APPROVAL <i>slw</i>	REQUEST FOR COUNCIL ACTION	MEETING DATE 12/19/17
REPORTS & RECOMMENDATIONS	STANDARDS, FINDINGS AND DECISION OF THE CITY OF FRANKLIN COMMON COUNCIL UPON THE APPLICATION OF KRONES, INC., PROPERTY OWNER, FOR A SPECIAL EXCEPTION TO CERTAIN NATURAL RESOURCE PROVISIONS OF THE CITY OF FRANKLIN UNIFIED DEVELOPMENT ORDINANCE	ITEM NUMBER G. 8

Standards, Findings and Decision
of the City of Franklin Common Council upon the Application of Krones, Inc,
property owner, for a Special Exception to Certain Natural Resource Provisions of the
City of Franklin Unified Development Ordinance

REPORT TO THE PLAN COMMISSION

Site Plan and Natural Resource Special Exception

NATURAL RESOURCE
PROTECTION PLAN
C5.0

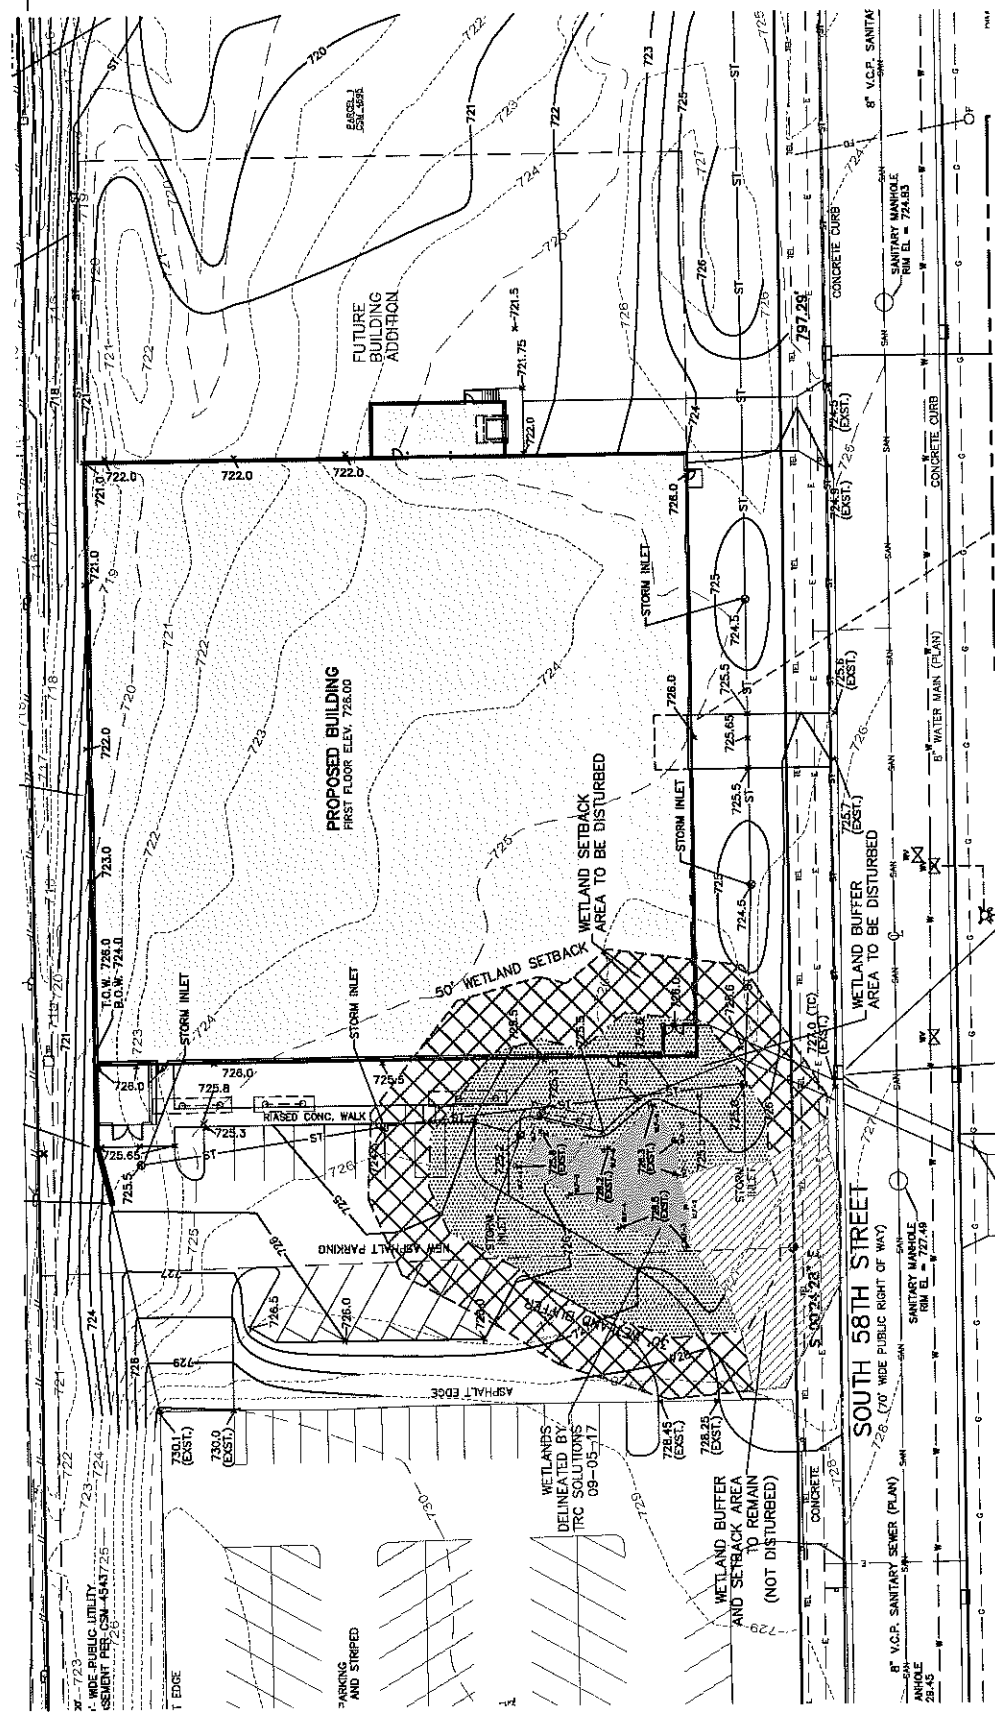
The applicant has filed a Natural Resource Special Exception Application requesting approval to permanently fill and remove approximately 6,750 square feet of wetland buffer and 13,670 square feet of wetland setback to allow for construction of the proposed building and parking lot.

The applicant is proposing to protect the wetland and a small area of wetland buffer and setback that remain outside of the disturbance limits for the project. The attached plans detail the request, including the location of the wetland and associated wetland buffer and wetland setback and proposed site improvements.

Staff recommends submittal of a mitigation plan, providing enhancements adjacent to the proposed stormwater pond onsite to compensate for the proposed impacts to the protected natural resource features being disturbed for Department of City Development review and approval, prior to issuance of a Building Permit.

- a. Approval of a Natural Resource Special Exception for Krones, Inc. based upon acceptance of site grading plan C1.0. and mitigation of wetland area to be located by pond to the north with Planning staff approval.
